BUCE AMERICAN MOTORCYCLES

B-011 February 25, 1997

SAFETY RECALL 0806 - M2 CYCLONE FRONT BRAKE LINE WIRE GUIDE

Figure 1. Removing Wire Guide

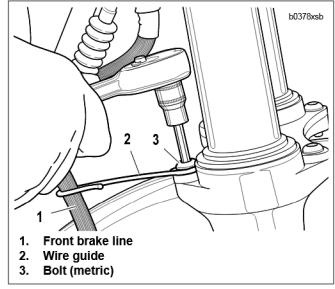
Buell has learned that the front brake line guide could cause the front brake line hose to kink during front brake operation. This could impede return brake fluid flow and prohibit the immediate release of the front brake caliper pistons. This could occur without prior warning. Rear brake performance is not affected.

As a precautionary measure, Buell Motorcycle Company elected to initiate a voluntary recall in the interest of motor vehicle safety. The condition will be remedied by removing the front brake line wire guide on all potentially affected vehicles.

- See Figure 1. If vehicle has a wire guide (2) installed around the front brake line (1), remove bolt (3) (metric).
- Remove end of wire guide from brake line. Cut wire guide into two pieces and discard.
- Apply two drops of LOCTITE THREADLOCKER 242 (blue) to threads of bolt (3) (metric). Install bolt and tighten to 10-12 ft-lbs (13.6-16.3 Nm).
